# Access Compliance Report Public Rights-of-Way (Curb Ramps)

Main Street: WENDY WAY Cross Street: MONTECITO\_RD Location: SE

ADA ID: RPRK211209132401 Ramp Type: Type 4 - Parallel Initial Pass/Fail: Fail Overall Compliance: No Severity Score: 15

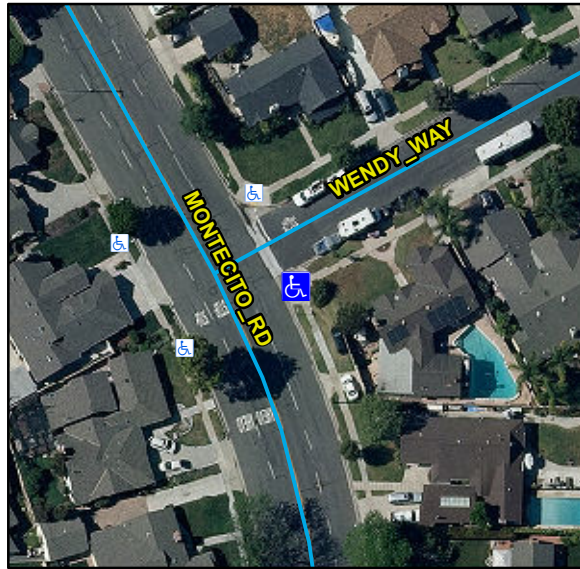
| Compliance | Description                   | Data       | Compliance | Description                   | Data |
|------------|-------------------------------|------------|------------|-------------------------------|------|
| Yes        | Ramp Cross Slope LT (%)       | 1.4        | No         | Ramp Cross Slope RT (%)       | 5.3  |

Remove & Replace Curb Ramp With Two New Directional Ramps or Equivalent.

R304.5.3, STD 1115
